Notice of Allowability

10/724,725

TSAO, CHUNG-MING

FIG.3

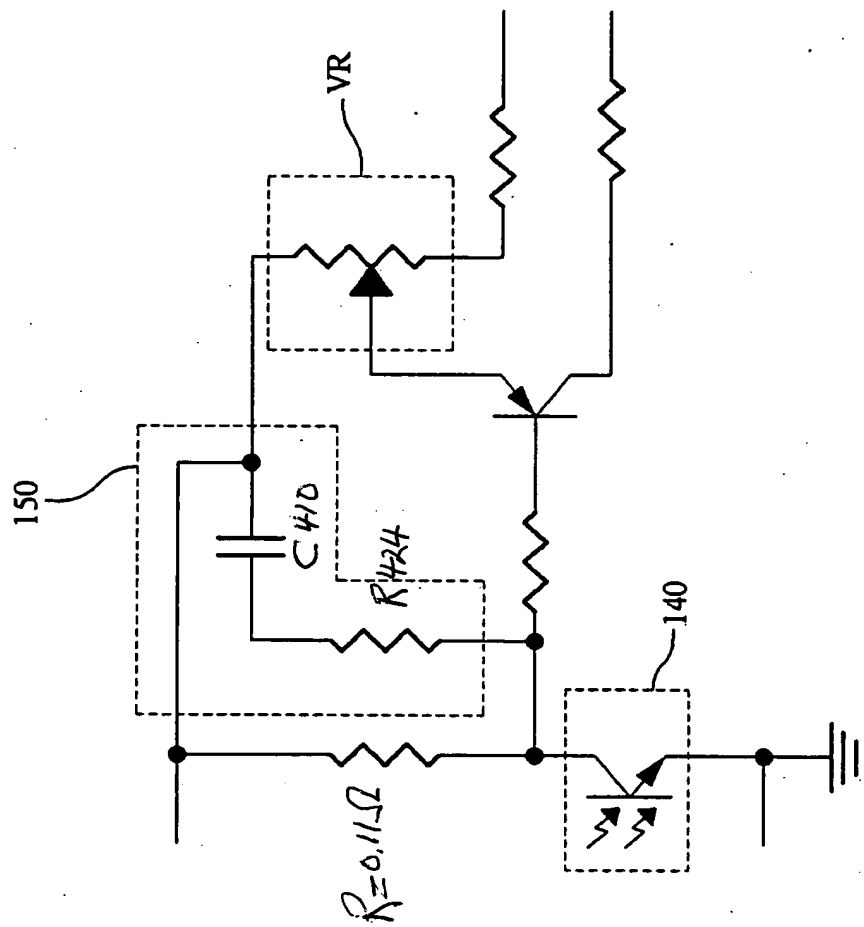
In the Drawings, Fig.3 has been labeled to show R, R424 and C410 as disclosed in the specification.
